HAY CREEK VALLEY
FINAL DRAINAGE REPORT

December 2023

Project No. 22.886.076

PCD File SF2324

Stormwater Detention and Infiltration Design Data Sheet

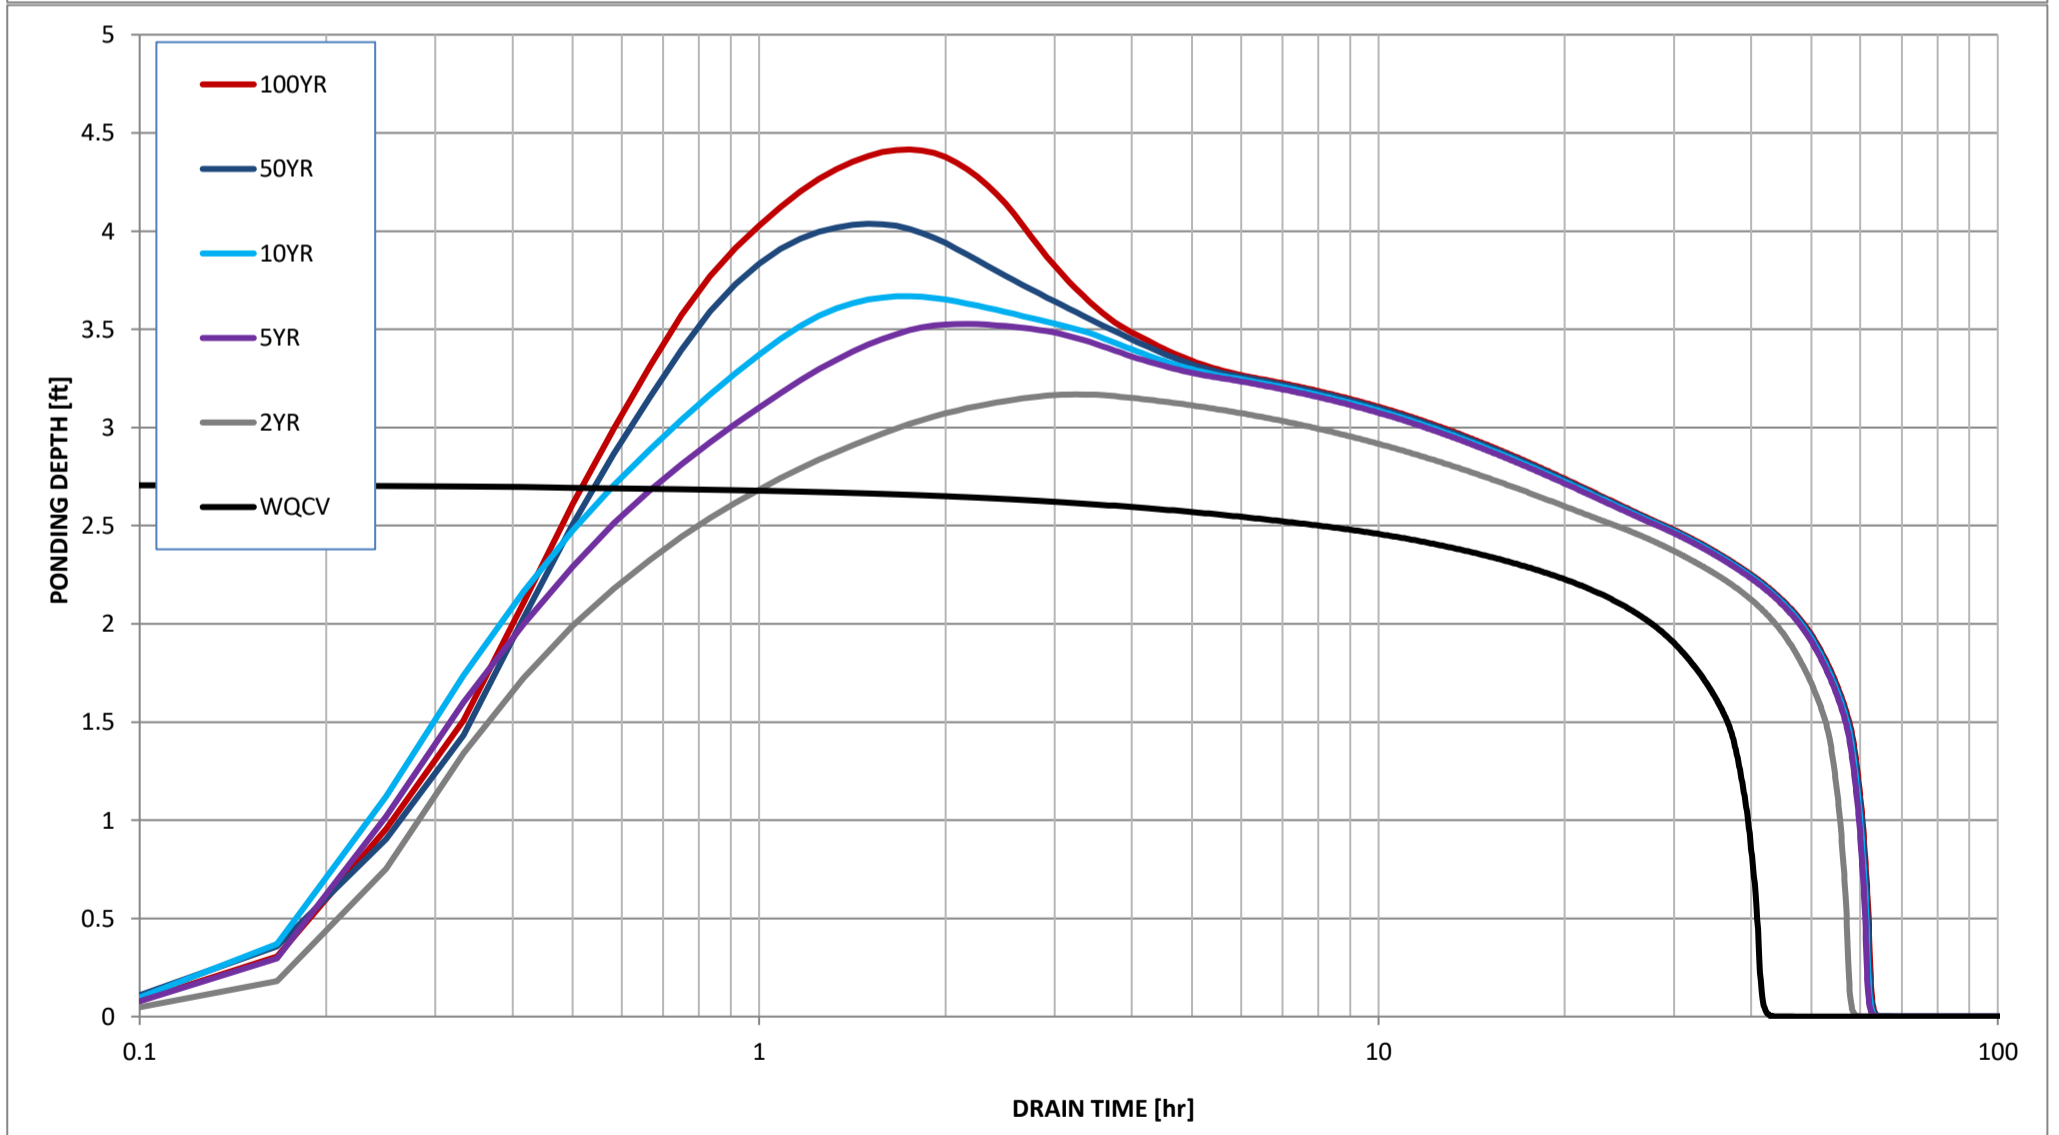
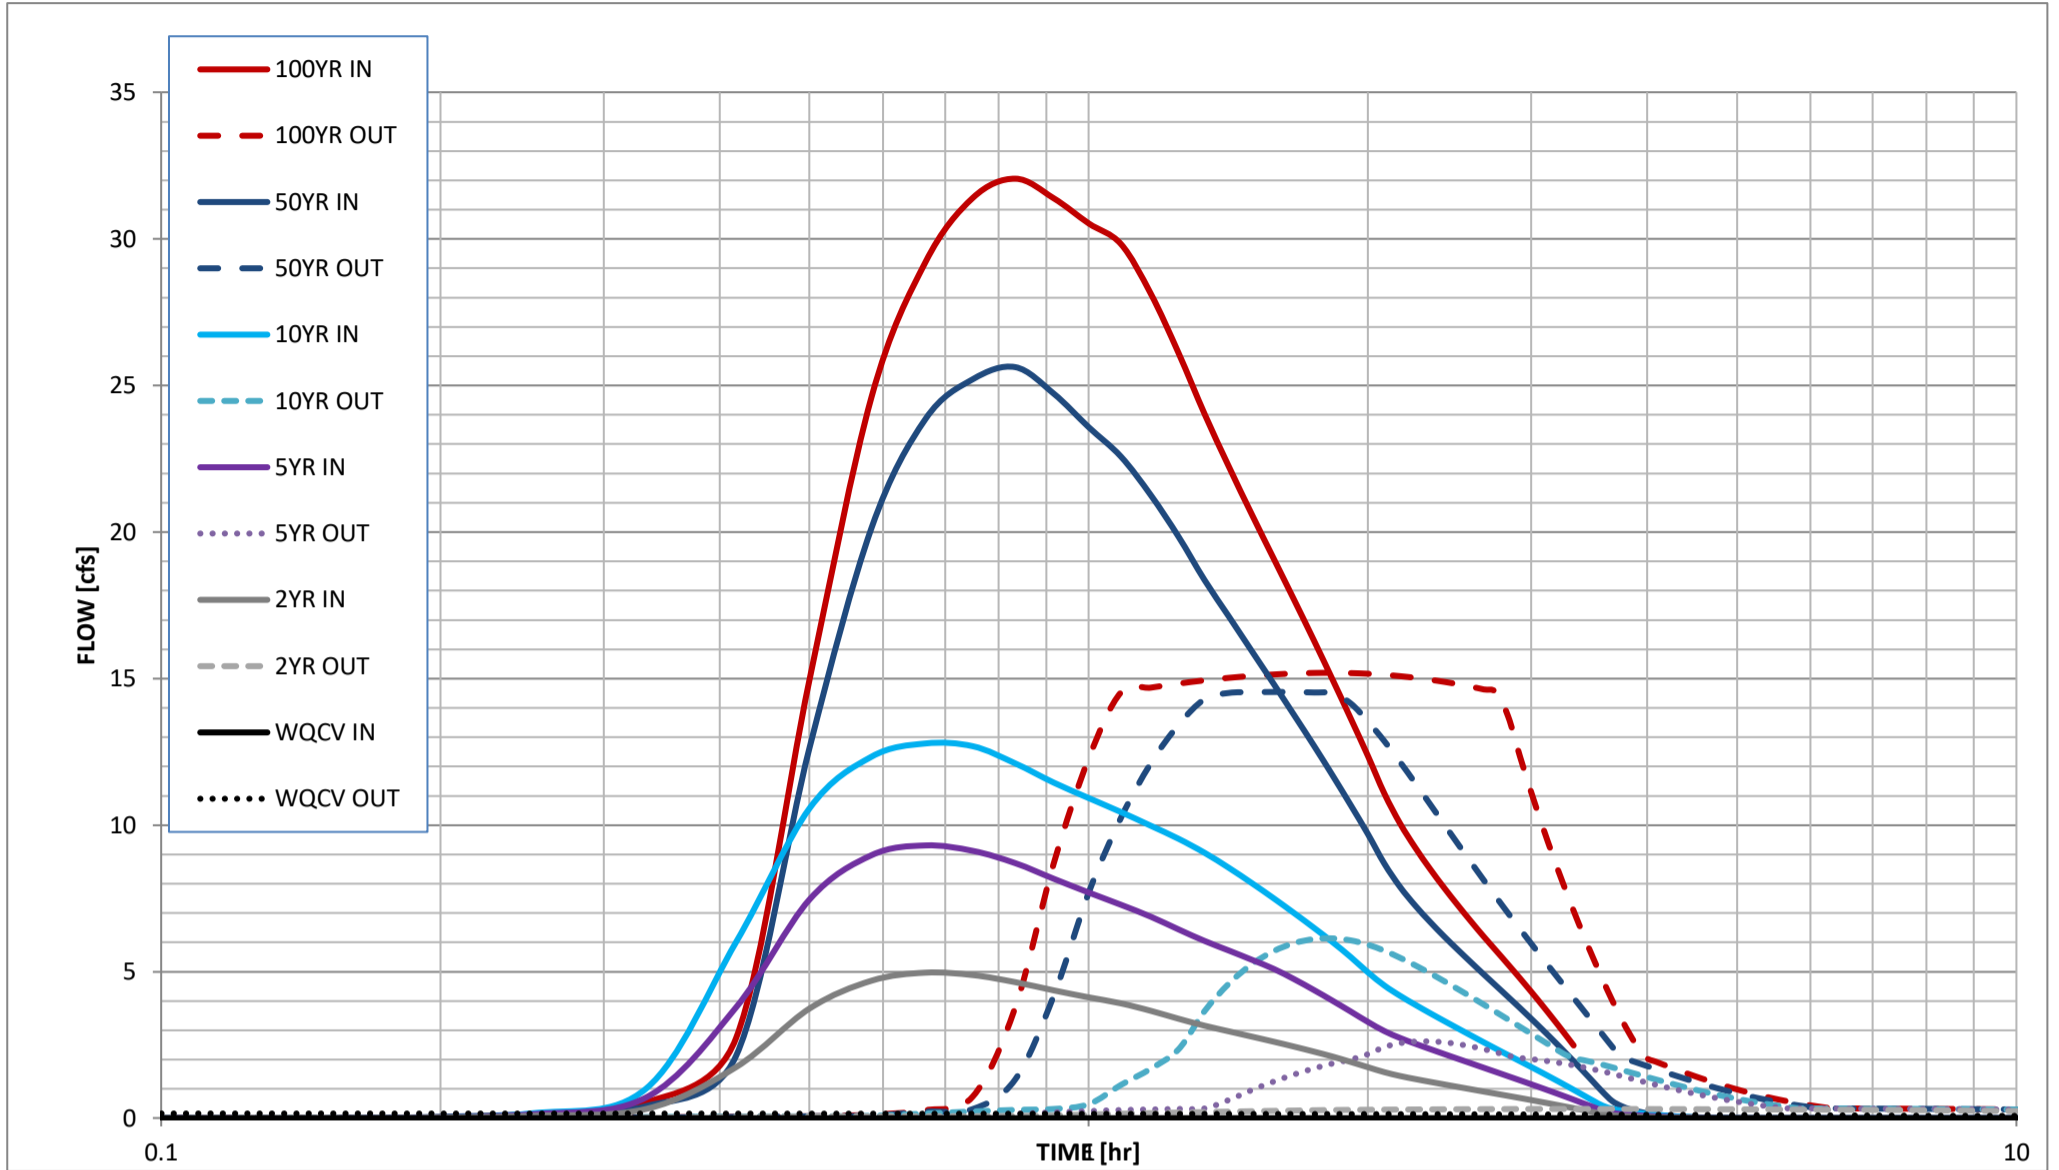
According to the table on the last page of this FDR, this UIA area should be 0.85ac or 37,026ac. Revise to remove discrepancy.

REVISED TO REMOVE DISCREPANCY

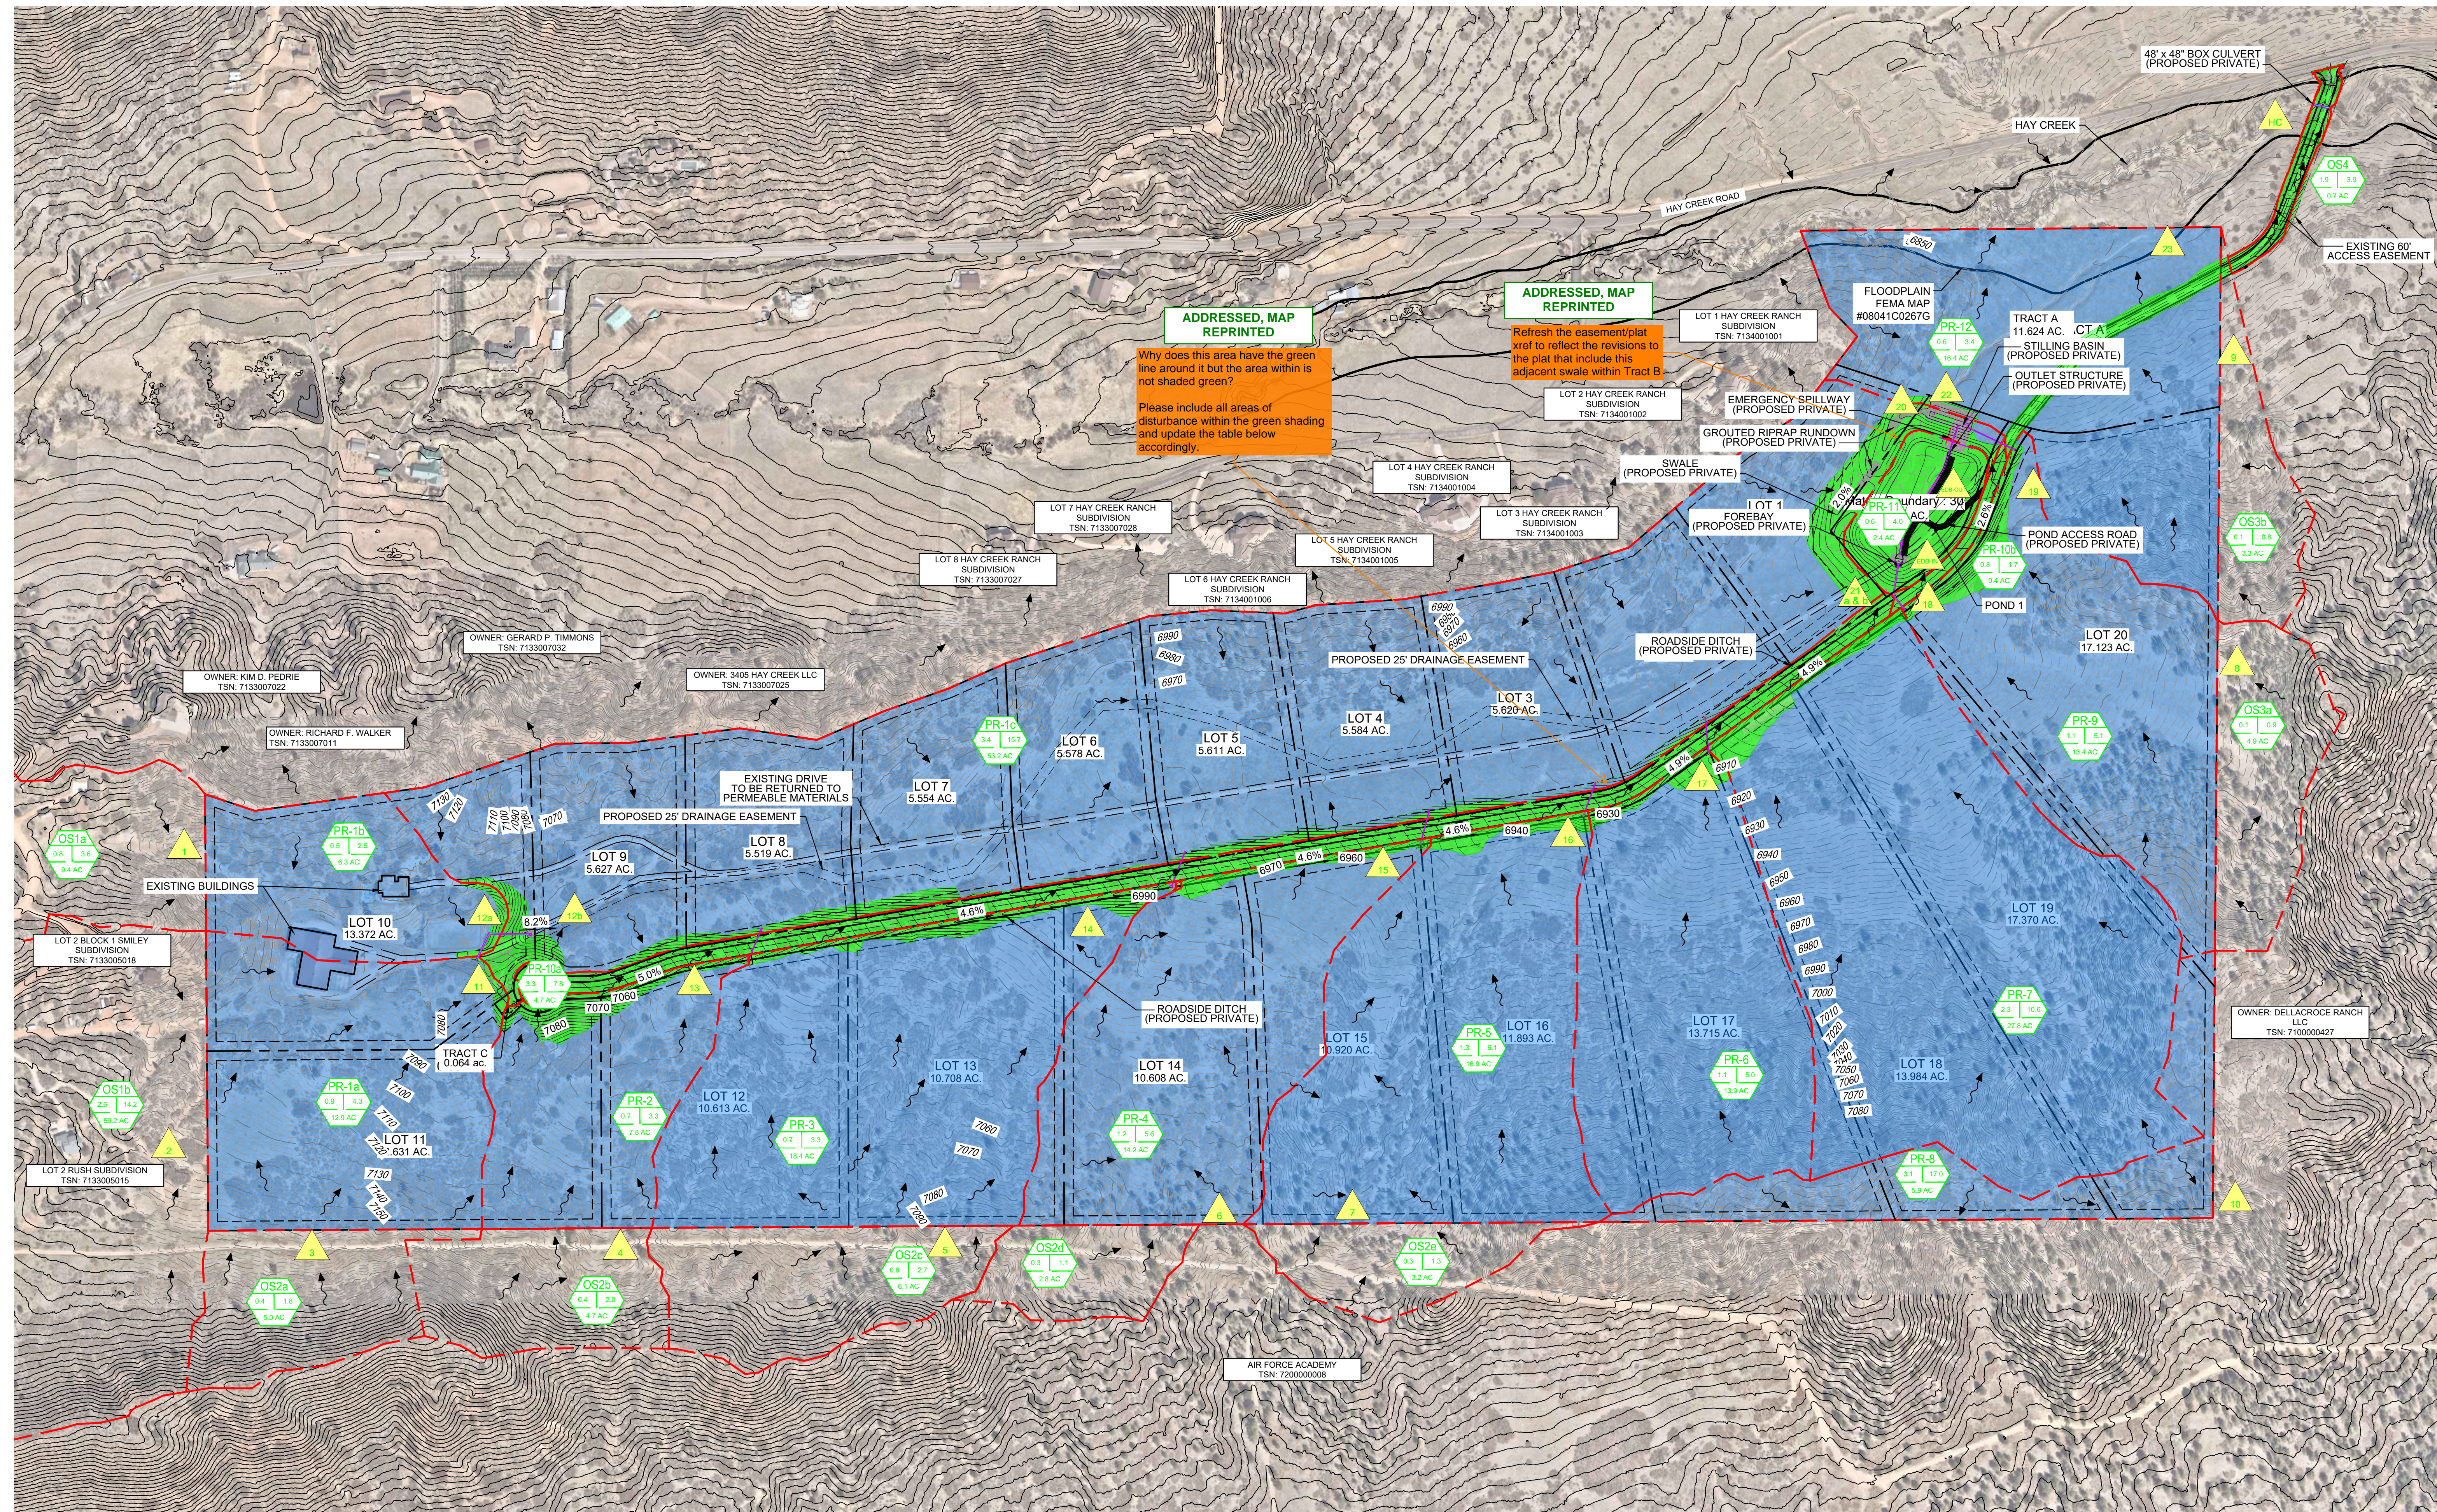
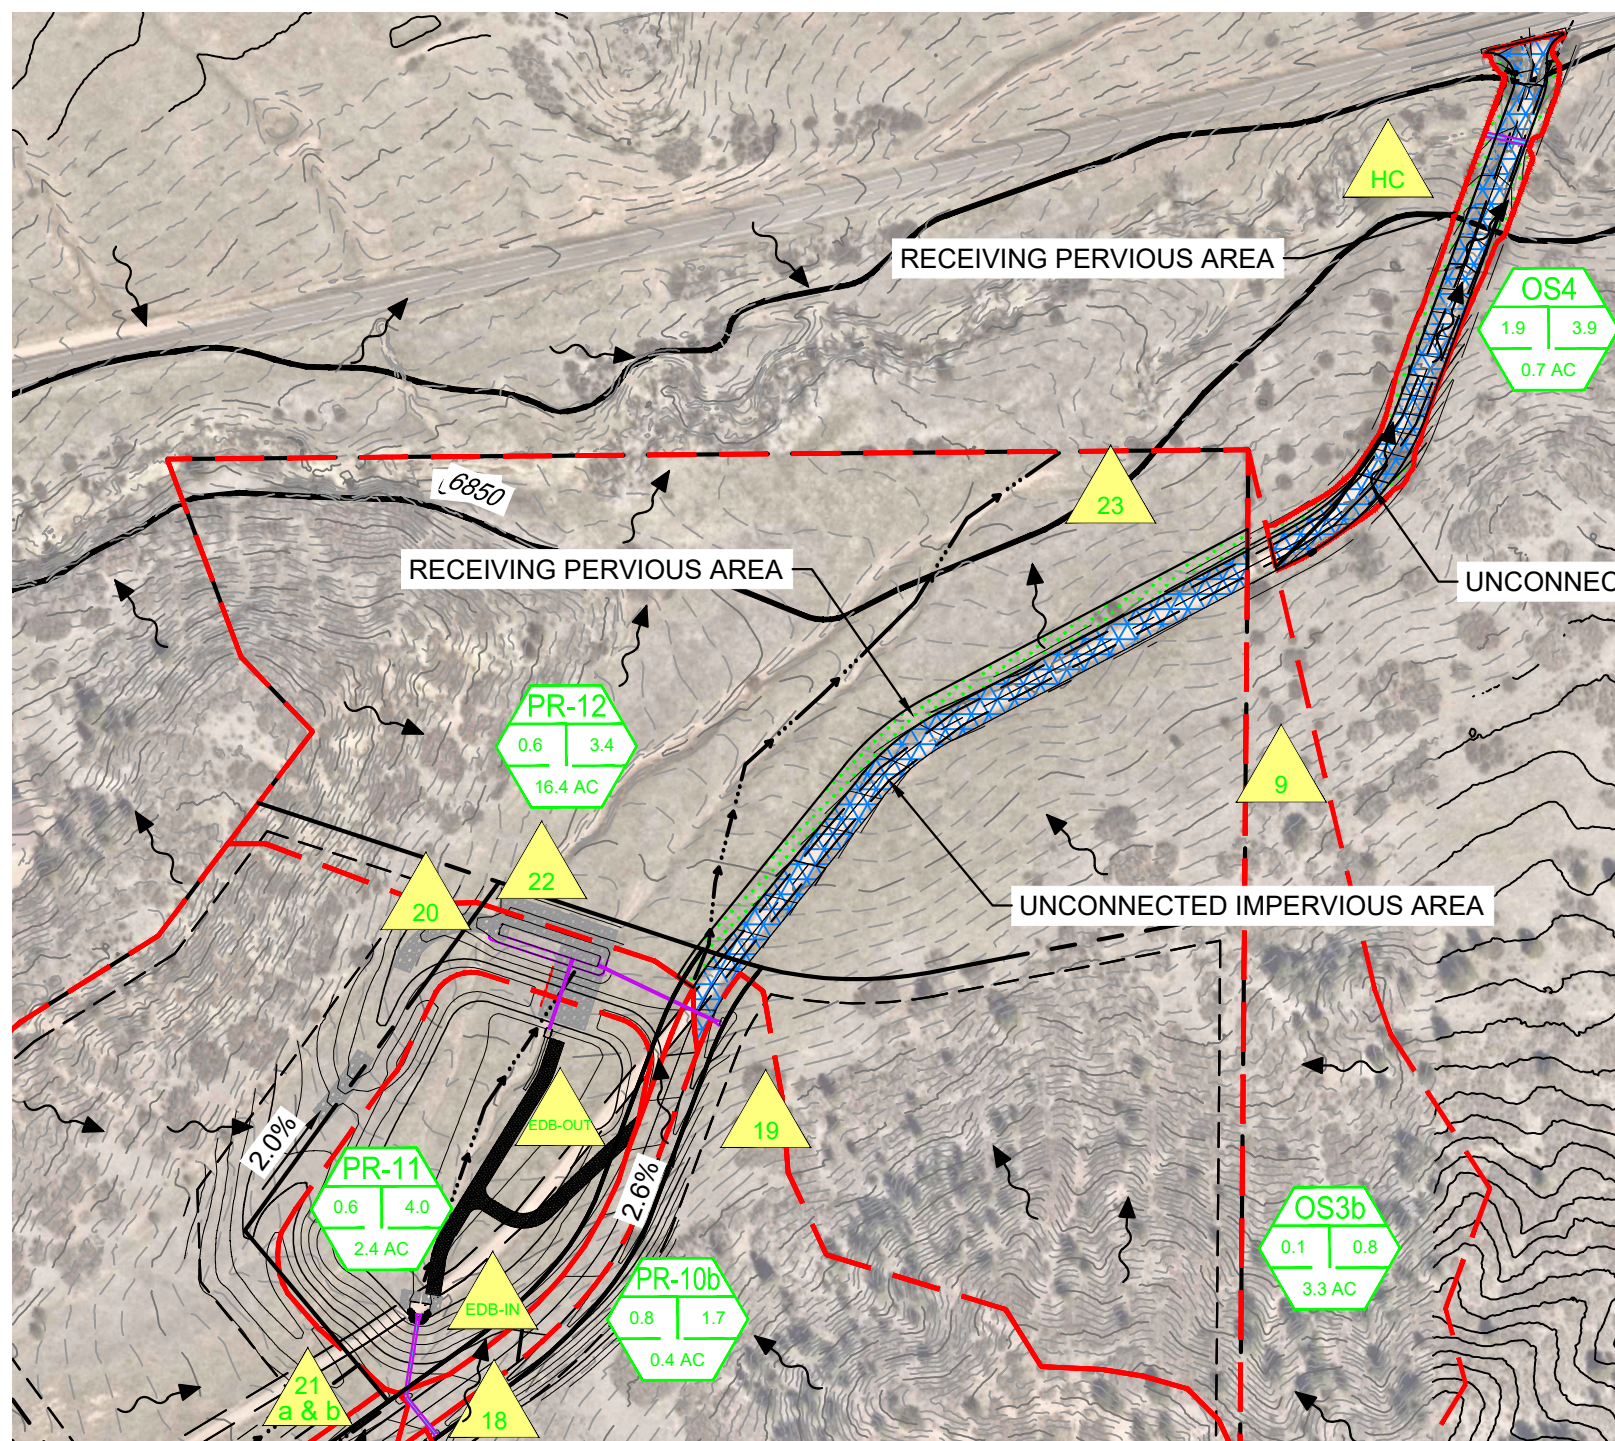
ADDRESSED, MAP REPRINTED
 Why does this area have the green line around it but the area within is not shaded green?
 Please include all areas of disturbance within the green shading and update the table below accordingly.

ADDRESSED, MAP REPRINTED
 Refresh the easement/plat xref to reflect the revisions to the plat that include this adjacent swale within Tract B
